IgCC – GENERAL

2014 PUBLIC COMMENT AGENDA FOR THE PROPOSED CHANGES TO THE 2012 IgCC

Figure 1- impact of encroachments into riverine flood hazard areas

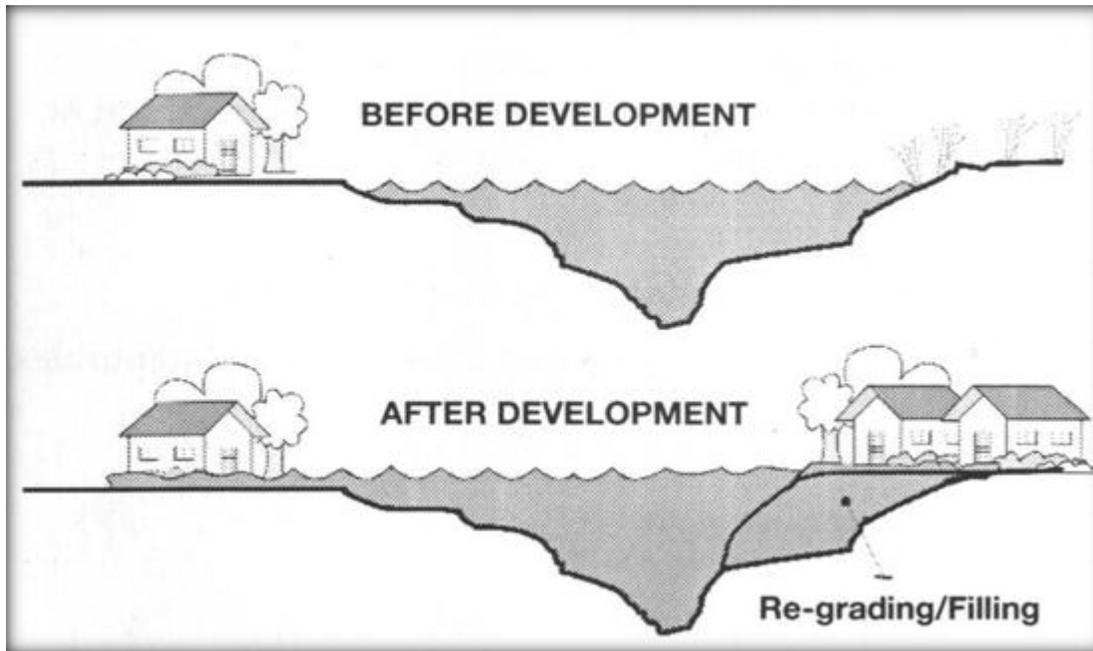
Reason: The costs of recovering from floods are the highest of all natural disasters and even with substantial federal, state and local government risk management efforts damage costs are on a steady upward trend. One of the reasons that the costs associated with flood recovery are increasing is encroachments into the floodplain (Galloway, 2013). Current minimum standards of the National Flood Insurance Program and the International Code Series -- and the current *International green Construction Code* -- allow encroachments into riverine floodplains that can cause up to a foot of increased flooding (see figure 1 below). These encroachments on-average pinch in conveyance areas to half their normal width, increase flood velocities by one-third and cause the extent of the flood hazard area to increase by 10 percent (Luloff, 2013).

It is important to note that this section, as written, only applies in riverine flood hazard areas, not in areas subject to coastal flooding where encroachments such as fill do not affect the base flood elevation in the same way they affect riverine floodplains.

FIGURE 505.3.1
HAIL EXPOSURE MAP

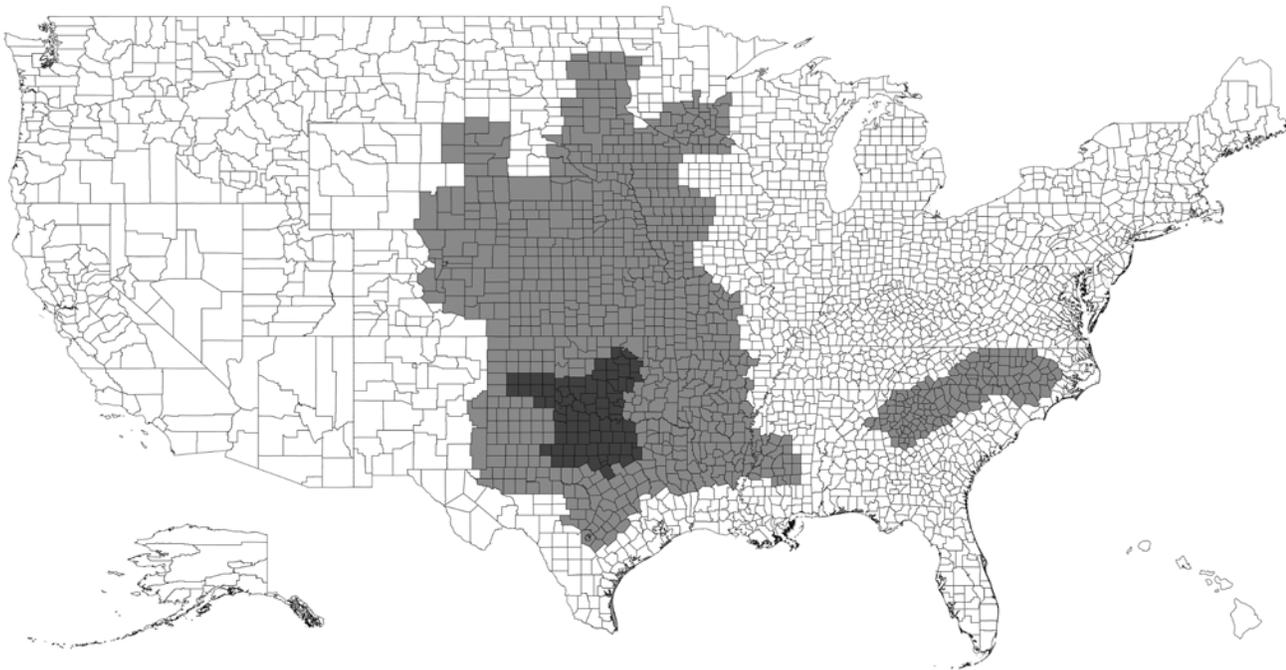
505.3 Roof coverings subject to hail exposure. Where indicated by Table 302.1, roof coverings used in regions where hail exposure is moderate or severe, as determined in accordance with Section 505.3.1 and Figure 505.3 shall be tested, listed, and labeled as Class 3 or Class 4 respectively in accordance with UL2218.

505.3.1 Hail exposure regions. Hail Exposure regions in Figure 505.3.1 shall be as follows:

FIGURE 804.3

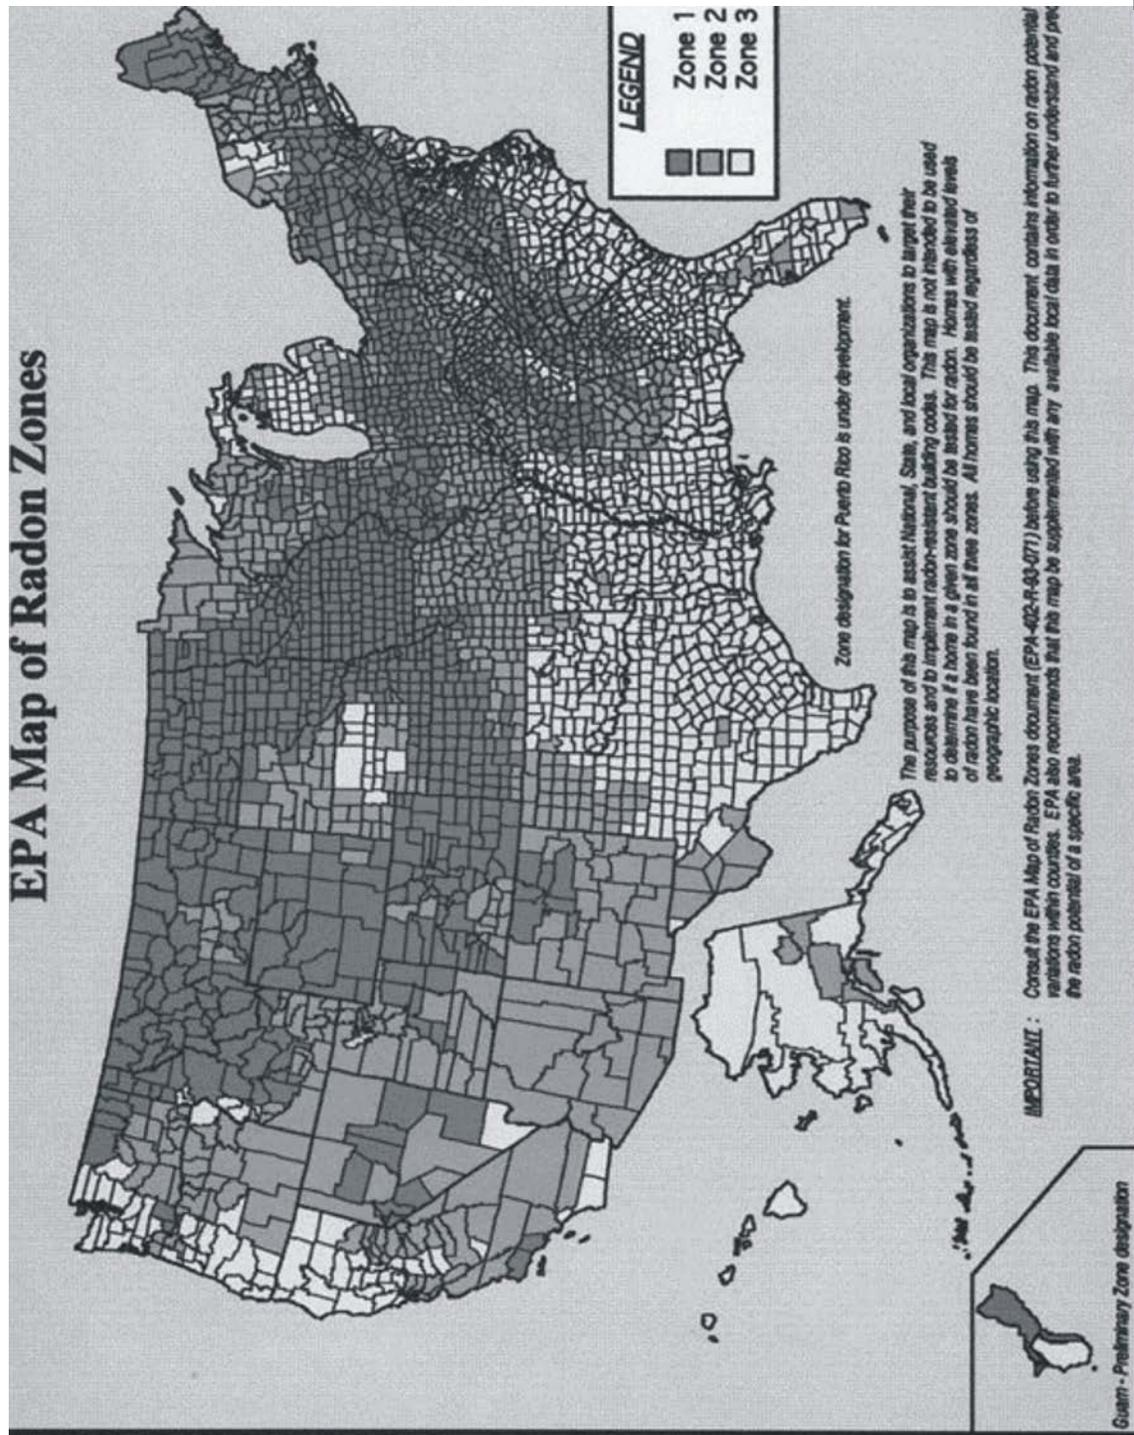
804.3 Radon Testing Where a building site indicates a potential for elevated indoor radon concentrations, as shown by the United States Environmental Protection Agency zones 1 and 2 in Figure 804.3 or from the United States Environmental Protection Agency radon potential by county listing in Table 804.3, radon testing shall be performed prior to occupancy of the building. Such testing shall be performed by a qualified radon measurement professional. Where state or local jurisdictions have published radon potential data, such data shall supersede the information in Figure 804.3 and Table 804.3. Indoor radon levels shall not exceed the United States Environmental Protection Agency Radon Action Level of 4 pCi/L.

FIGURE B101.1 FIGURE 809.1
EPA MAP OF RADON ZONES

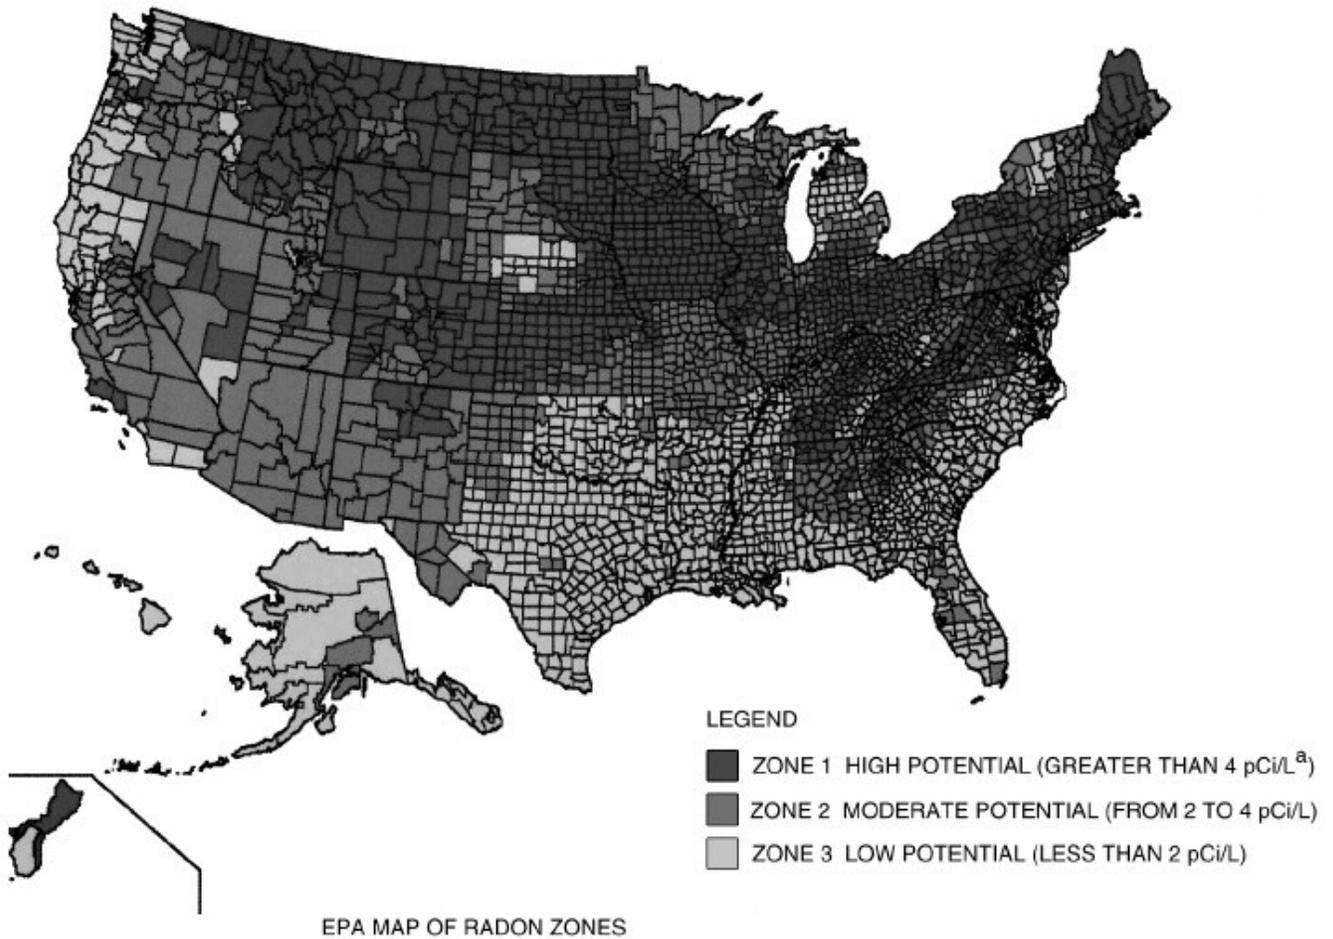
B101-809.1 Radon mitigation. Buildings in areas of High and Moderate Radon Potential (Zone 1 and 2), as determined by Figure 809.1 B101.4 and Table 809.1 B101.4 shall comply with Sections 809.2.1 B201.1 through 809.2.12 B201.10.
